County of San Diego  
Planning & Development Services  
**BUILDING DIVISION**

ACCESSIBILITY CORRECTION LIST

Multifamily Housing

**Elevators and Platform Lifts**

FIGURE 11A-7A  
MINIMUM DIMENSIONS OF ELEVATOR CARS

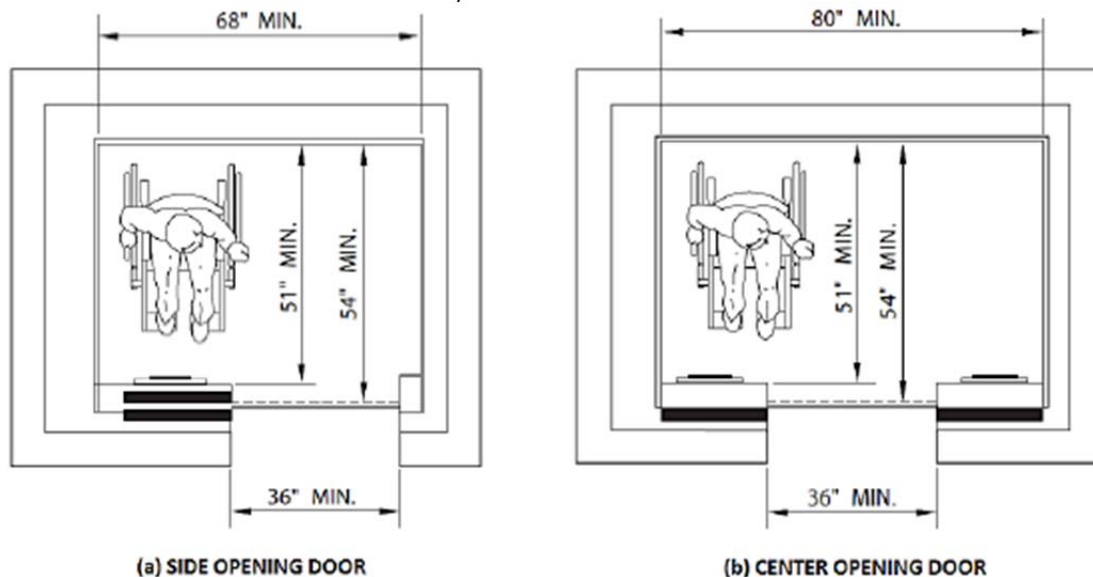
3. Dimension elevator car interior complying with the following:

- ☐ For elevator cars with side-opening doors, minimum 68 inches between side walls per CBC Figure 11A-7A(a)
- ☐ For elevator cars with center-opening doors, minimum 80 inches between side walls per CBC Figure 11A-7A(b)
- ☐ Minimum 54 inches between rear wall and door
- ☐ Minimum 51 inches between rear wall and return panel

**FIGURE 11A-7C  
HOISTWAY AND ELEVATOR ENTRANCES**

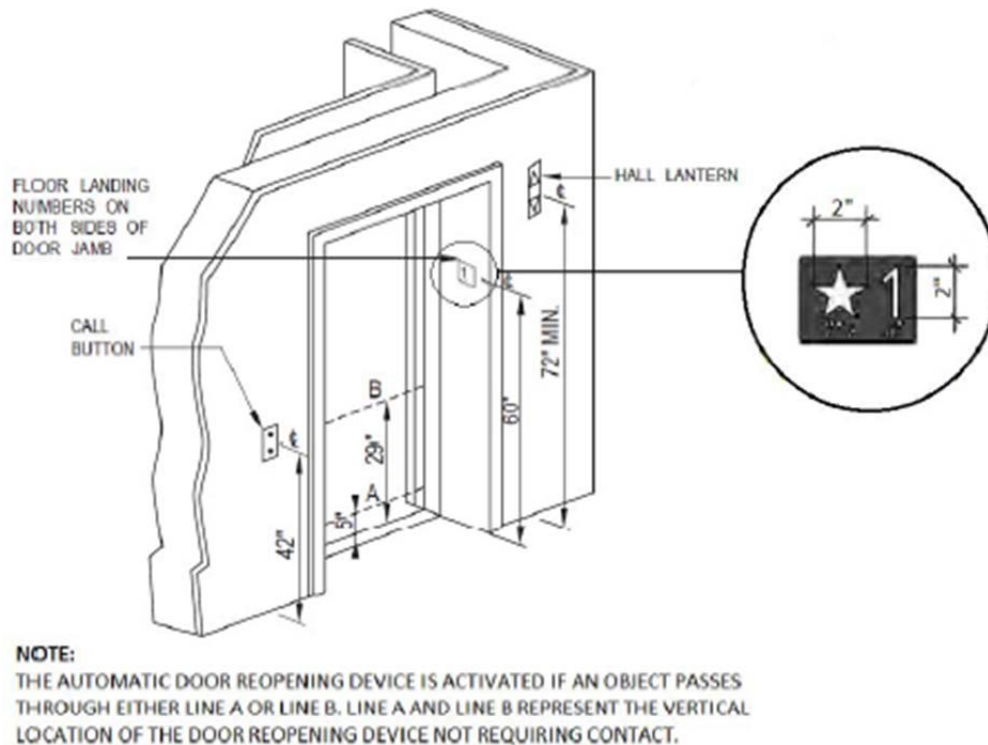
6. Detail doorjamb marking complying with the following at each lobby elevator hoistway entrance per CBC Figure 11A-7C:
  - ☐ Indicating respective floor number
  - ☐ Located on both sides of door and visible from within elevator car
  - ☐ Centered 60 inches (absolute) above lobby floor
  - ☐ Floor numbers designated by raised characters minimum 2-inches high on contrasting background and otherwise complying with item 26
  - ☐ Grade level designated by raised five-pointed star with 2-inch (absolute) outside diameter placed to left of floor-designation number on contrasting background and otherwise complying with item 26
  - ☐ Corresponding Braille per item 27 beneath raised characters

**FIGURE 11A-7B  
ELEVATOR CONTROL PANEL**

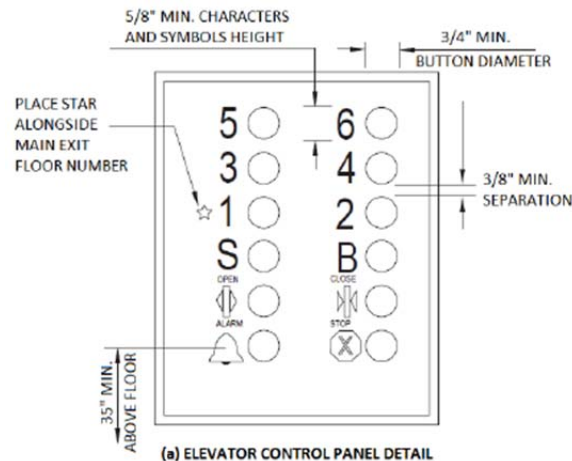
11. Detail car control and emergency buttons complying with following per CBC Figure 11A-7B(a):
- ☐ Minimum 3/4-inch-diameter control buttons raised 1/8 inch +/- 1/32 inch above surrounding surface

- ☐ Illuminated control buttons with square shoulders and activated by detectable mechanical motion
  - ☐ Minimum 3/8-inch clear space or separation between rows of control buttons

- ☐ Raised characters per the following:
    - o Located immediately to left of control buttons
    - o White on black background
    - o Otherwise complying with item 26

- ☐ Raised symbols per the following:
    - o Provided for controls and emergency equipment including – but not limited to – “door open,” “door close,” “alarm bell,” “emergency stop,” and “telephone”

- o Five-pointed star at call button for main entry floor
    - o Located immediately to left of control buttons
    - o White on black background
    - o Otherwise complying with item 26

- ☐ Corresponding Braille per item 27 beneath raised characters and symbols
